**Landscape Plan**  
*FedEx Ground*  
40 Kennedy Road  
South Windsor, Connecticut

We are pleased to advise you that the Planning & Zoning Commission voted on February 8, 2010 to approve with modifications the above referenced application for a Site Plan of Development.

- Appl. 11-05P, FedEx Ground – request for a site plan approval to construct approx. 288,901 sf in two phases, on 60+ acres of property located on the northerly side of Sullivan Ave. and easterly side of Kennedy Road, I zone

We are pleased to advise you that the Planning & Zoning Commission voted on March 11, 2015, to approve with modifications the April 15, 2015, site plan application for a 292,000 sq. ft. distribution facility on 16.4 acres of property located at 153 Sullivan Avenue, South Windsor, CT and as more specifically shown on plans entitled "Sullivan Avenue Industrial Park, Subdividing Multi-Modal Pathway, 153 Sullivan Avenue, South Windsor, CT, Sheet #1, L&A1 & L&A2, dated 1/20/2015, and Sheets UT-1, and UT-2 "Utility Plan". This approval is subject to the following conditions:

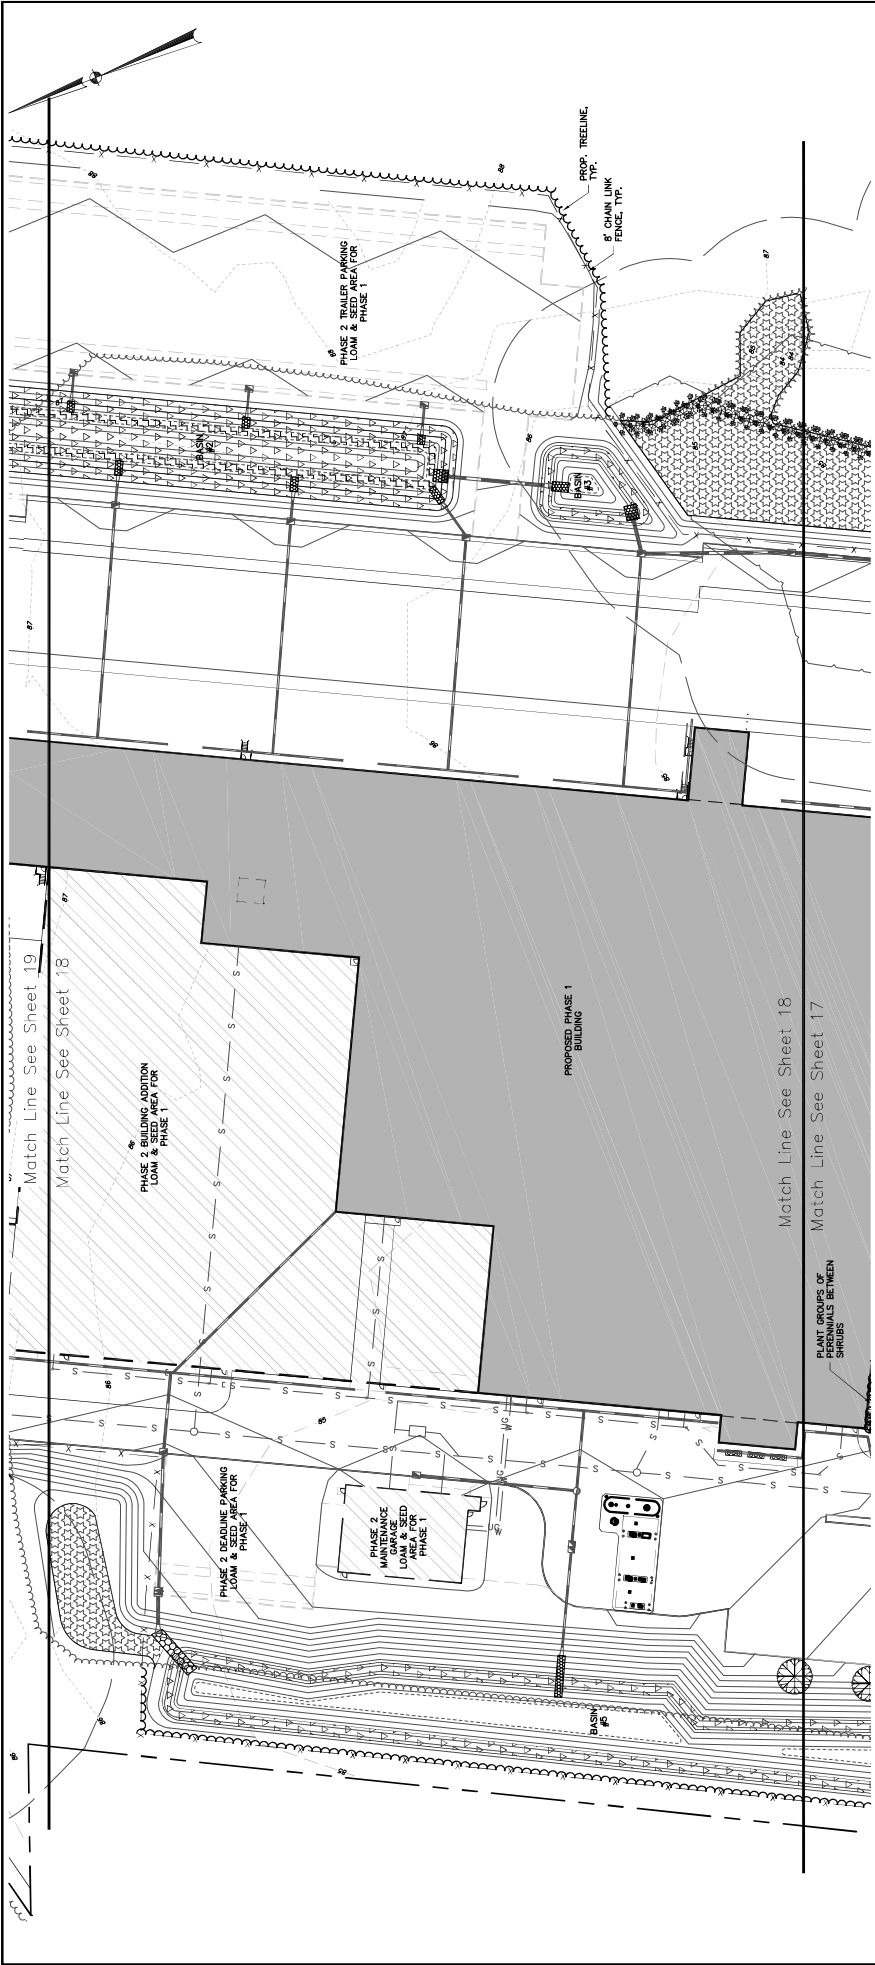
- I see that the landscape plans have been revised to relocate trees and shrubs away from underground utilities. Add a note to the landscape plans stating that trees or shrubs shall not be planted within 10 feet of any underground utilities to alert the landscape contractor to check the location of underground utilities before they install trees and shrubs.
